# Wyoming State Fire Marshal

Occupancy: **Absaroka Head Start Basin**

Inspection Type: **Reinspection**

Inspection Date: **9/12/2022**

## Exits

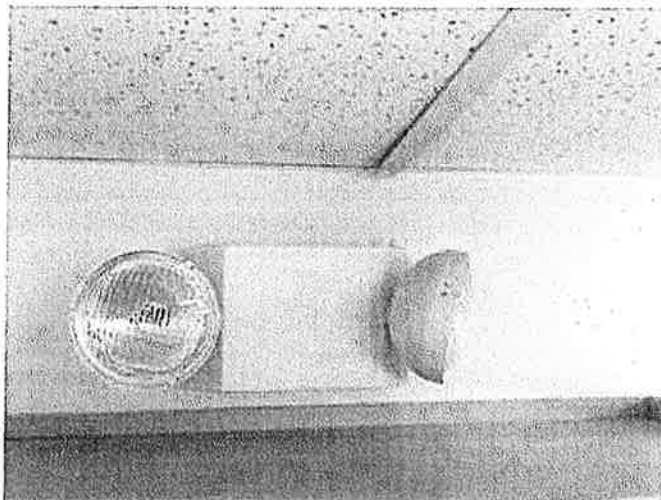
1008.3.2; Means of egress illuminated at all times. emergency power supply

**Notes:** Emergency light is not working. Replace the battery or replace the light

9-12-22 The light has been replaced and is functioning.
